2.0 SITE CHARACTERISTICS

This chapter of the application describes the site-specific characteristics that could affect the safe design and siting of the plant.

Figure 2.3S.2-1. Comparison of 1997, 1999, and 2000 Wind Direction Frequency Distributions

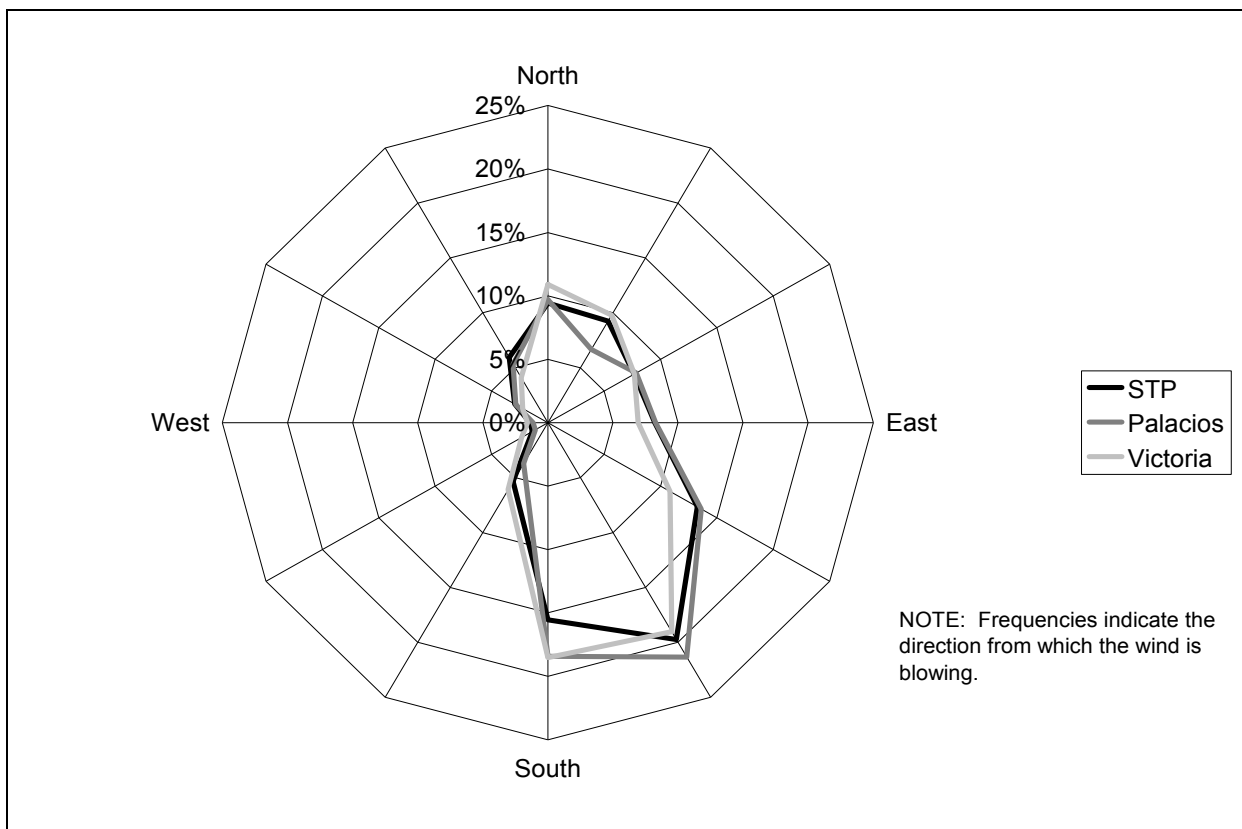
In order to confirm this hypothesis, the staff generated a comparison of annual wind direction frequencies among the STP, Palacios, and Victoria hourly data for the years 1997, 1999, and 2000. This comparison, shown in SER Figure 2.3S.2-1, indicates a similar distribution among all three sites. The staff also compared annual average wind speeds among all three sites for the same three-year time period. The staff found that the STP 10-m (33-ft) level average wind speed of 4.1 m/s (13.5 ft/s) is consistent with the 6.1-m (20.0-ft) level average wind speed of 4.1 m/s (13.5 ft/s) at Victoria but somewhat lower than the 5.0 m/s (16.4 ft/s) average wind speed recorded at Palacios. The staff issued RAI 02.03.02-4a requesting the applicant to justify not including meteorological data from Palacios in the review of average wind direction and wind speed conditions discussed in Revision 0 of FSAR Tier 2, Section 2.3S.2.2.1.

Figure 2.3S.3-3. STP Stability Class Frequency Distributions

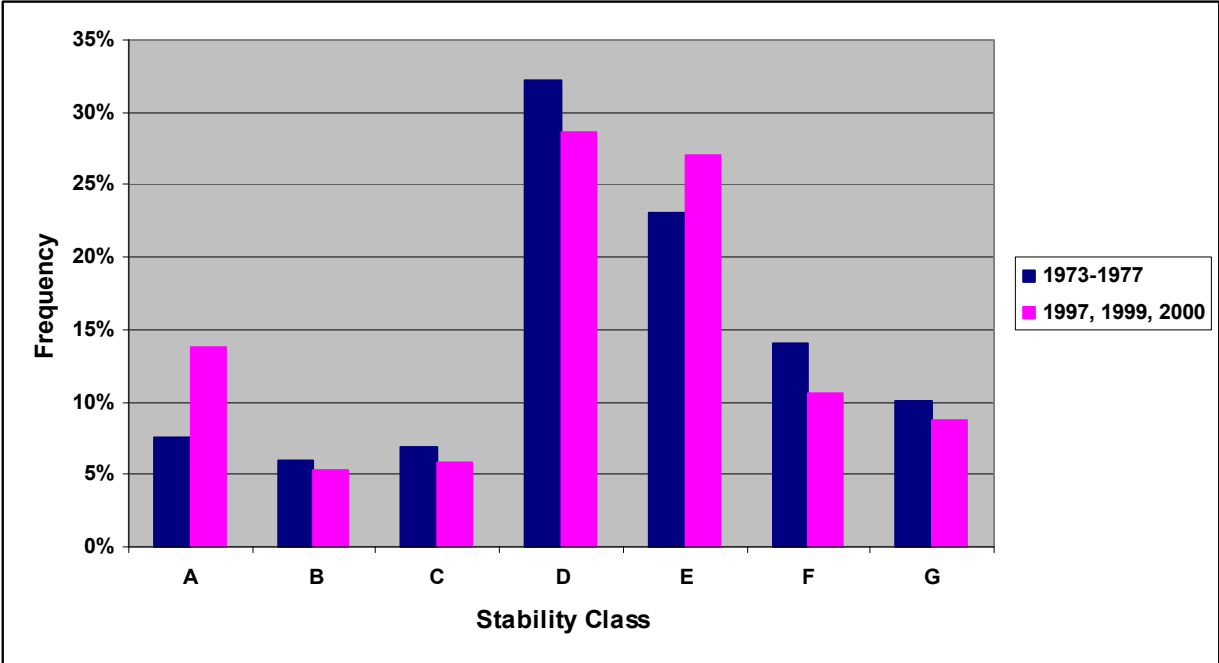
The stability class frequency distribution for both data sets in SER Figure 2.3S.3-3 also show reasonable agreement. Nonetheless, the staff issued RAI 02.03.03-3 asking the applicant to explain the 6 percent frequency increase of onsite Stability Class A (extremely unstable) conditions from the original data set to the current data set (see SER Figure 2.3S.3-3).
